Santa Ana River Wasteload Allocation Model Update

BASIN MONITORING PROGRAM TASK FORCE

November 16, 2017

Response to Comments on TM No. 1

Draft TM 2 Figure 42

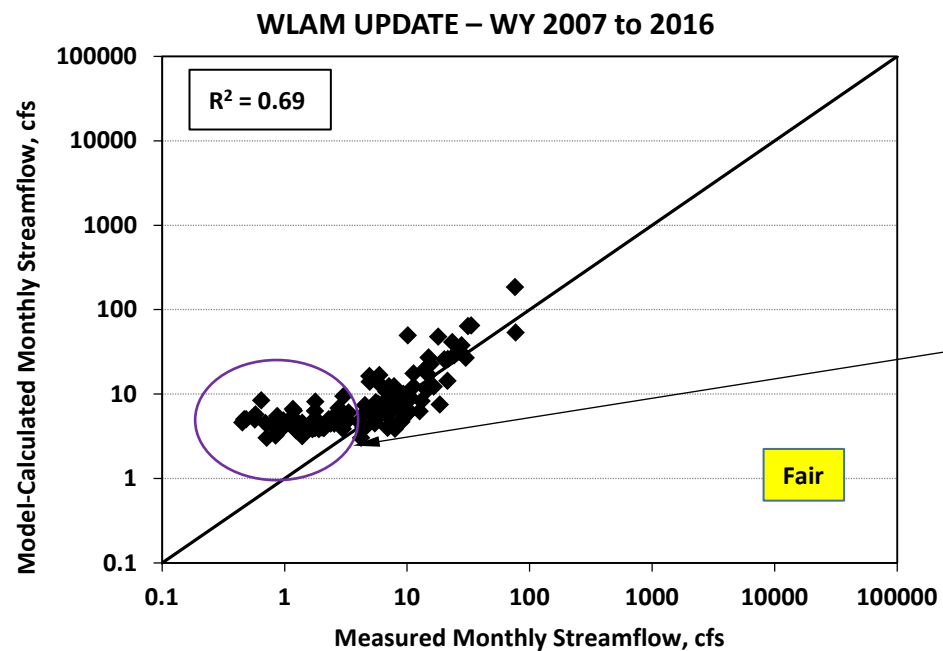
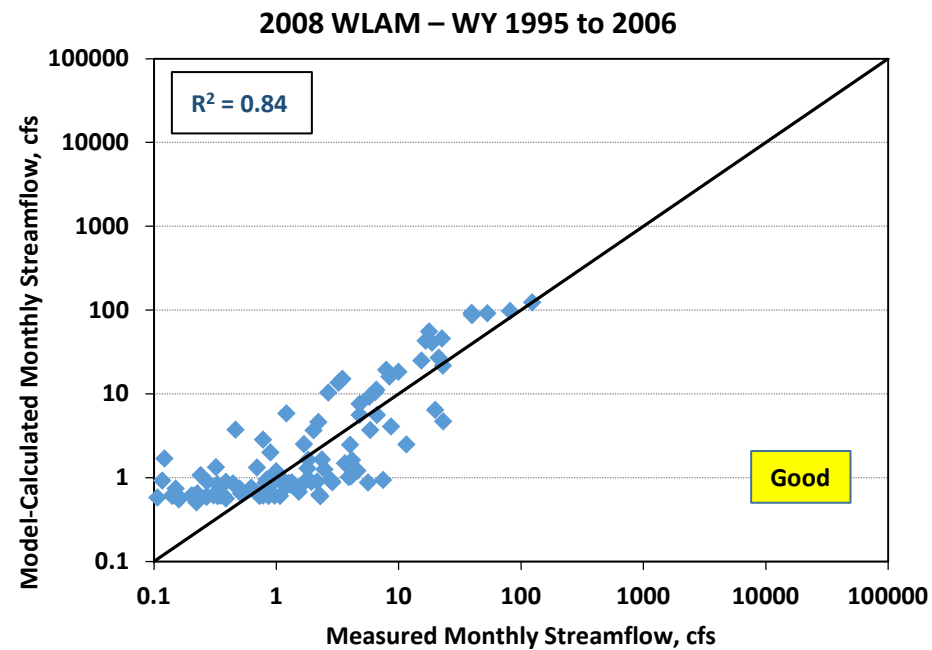
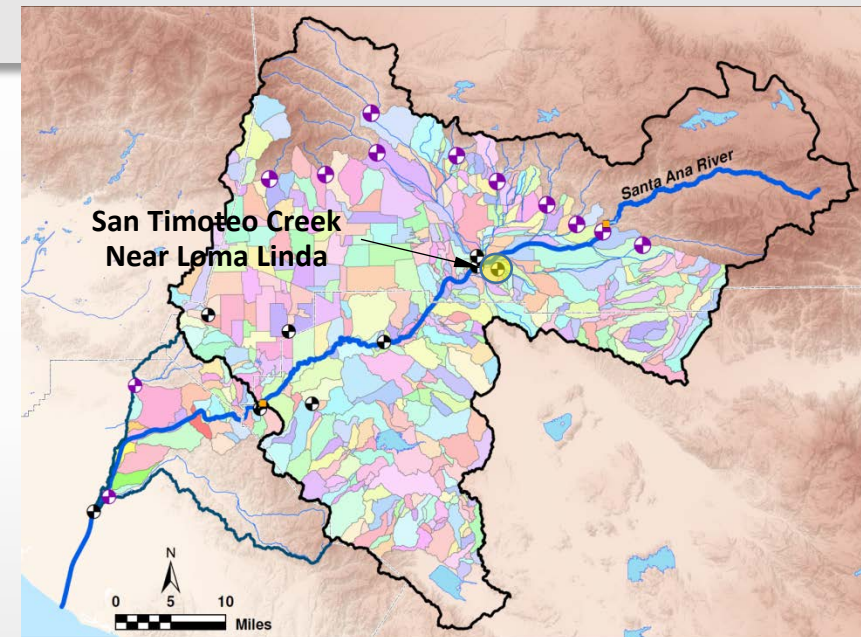
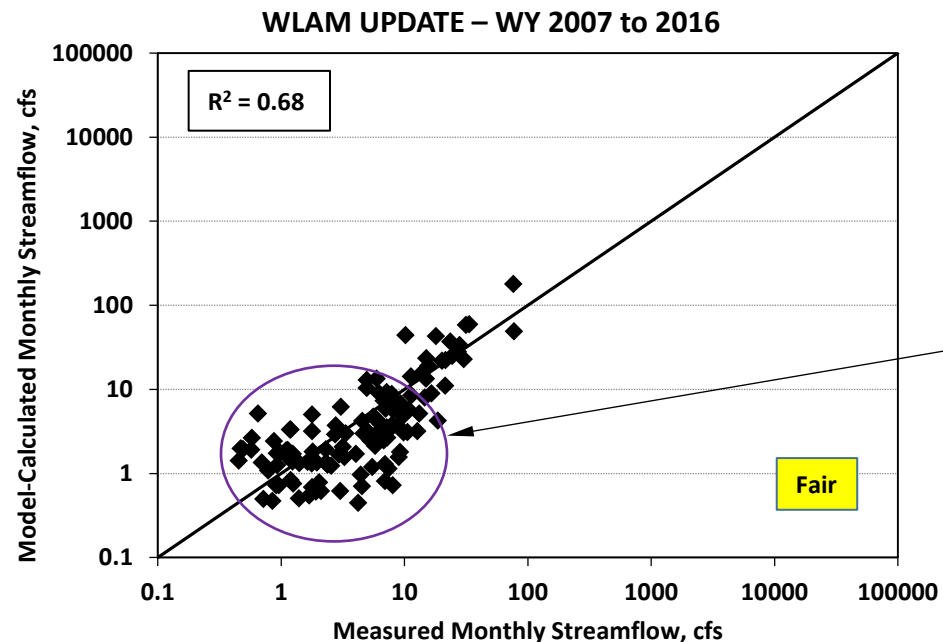
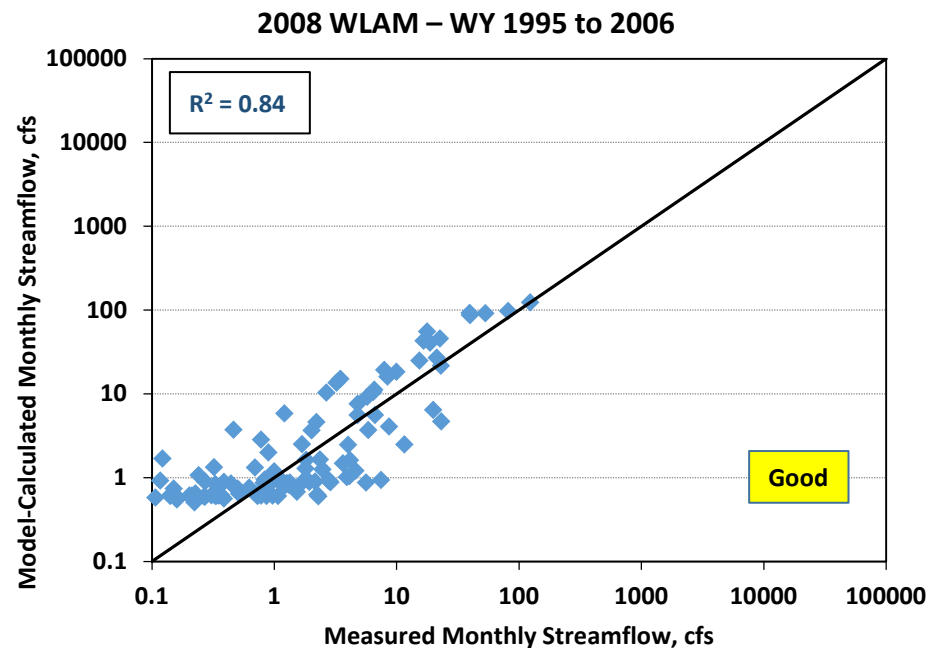
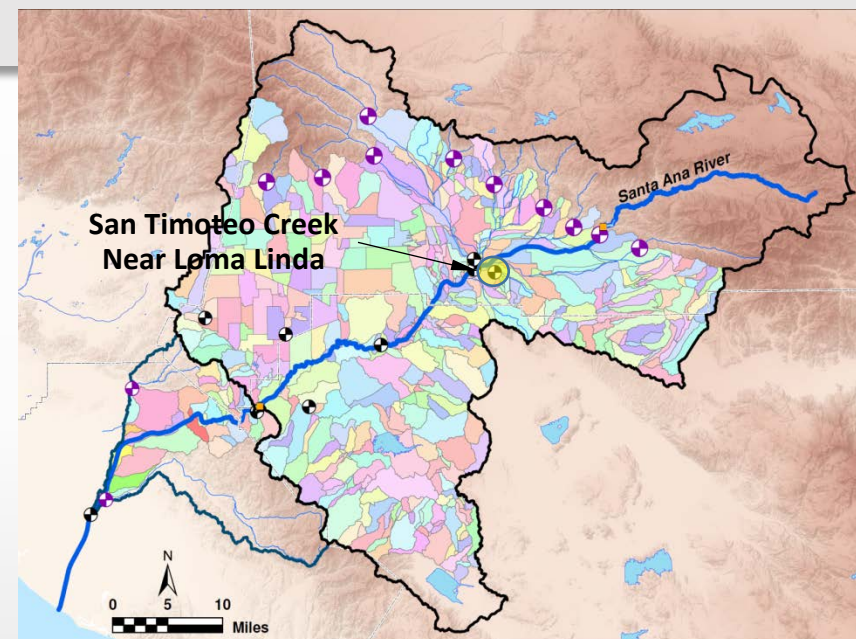
No.	Section	Pg.	Comment	GEOSCIENCE Response
4	3.3	15	Provide an explanation for the reduction in model performance between the 2008 WLAM (R4) and the WLAM Update (HSPF) seen at the San Timoteo Creek near Loma Linda and Temescal Creek at Main Street gaging stations.	Model will be refined to improve model calibration.

Model overestimates
streamflow

Revised TM 2 Figure 42

Baseflow calibration improved slightly. However, R^2 was not improved

Figure 20

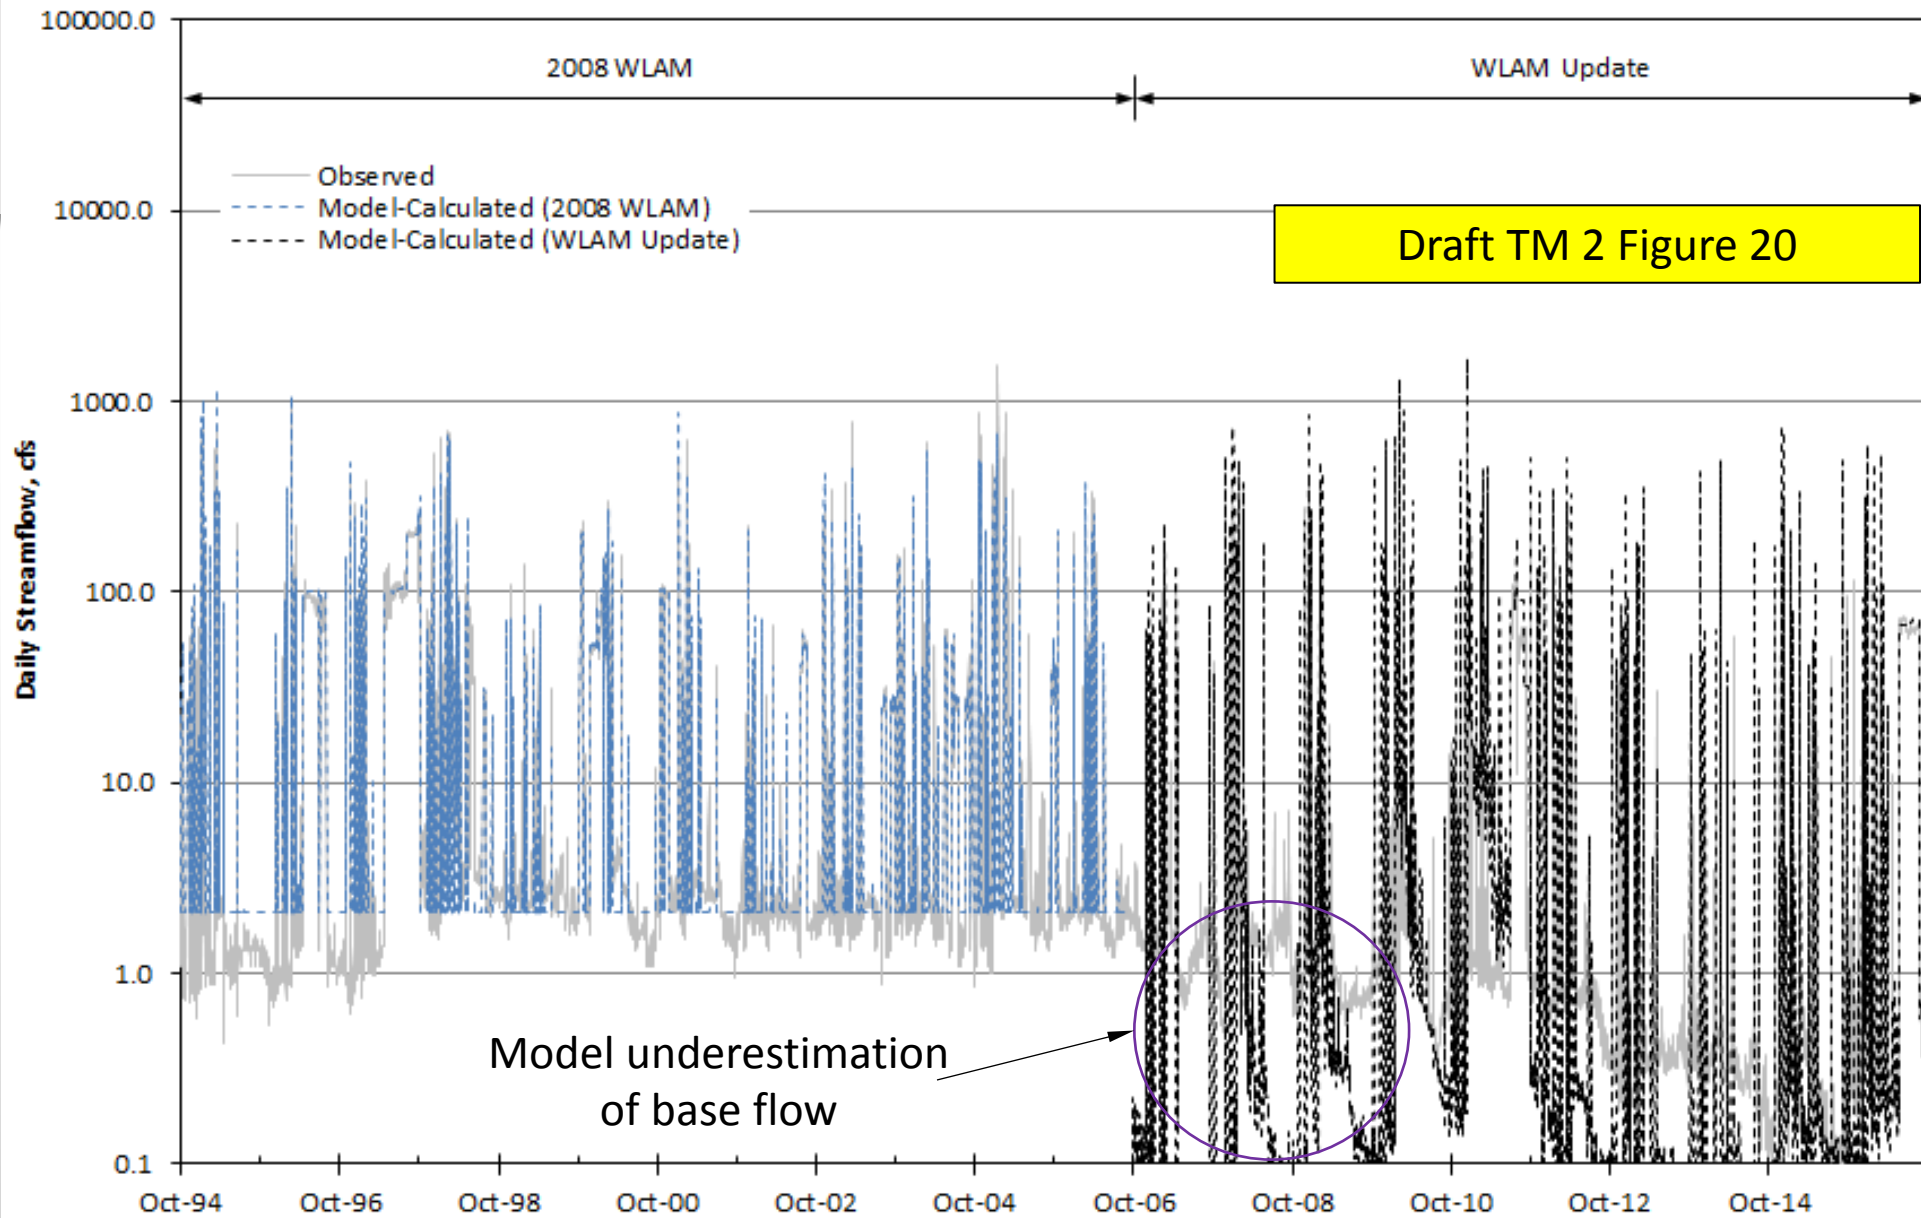
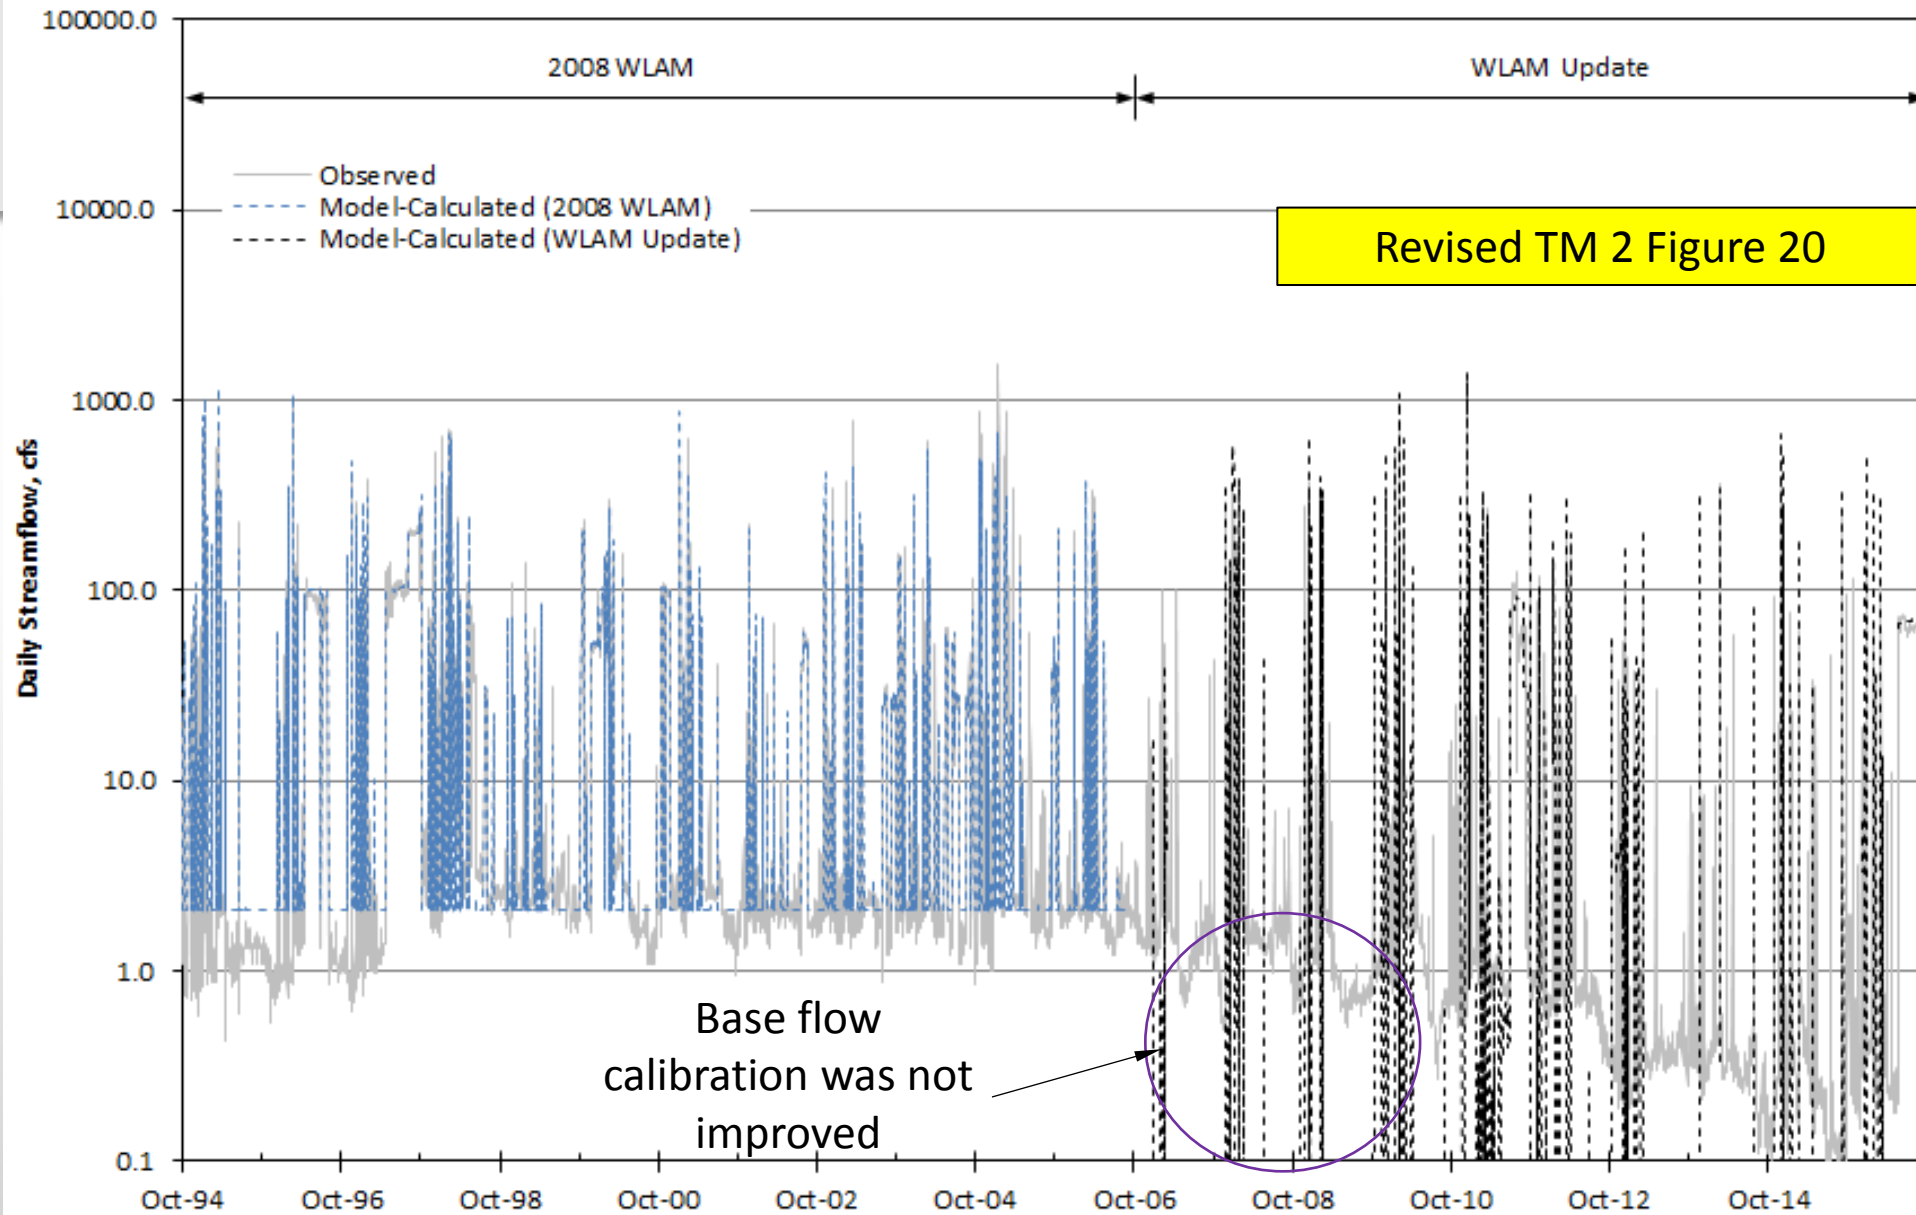
No.	Section	Pg.	Comment	GEOSCIENCE Response
6	General	-	Revisit areas where the model is over/underestimating streamflow and may need improvement (e.g., Figures 20, 21, 24, and 28).	Underperforming areas will be revisited.
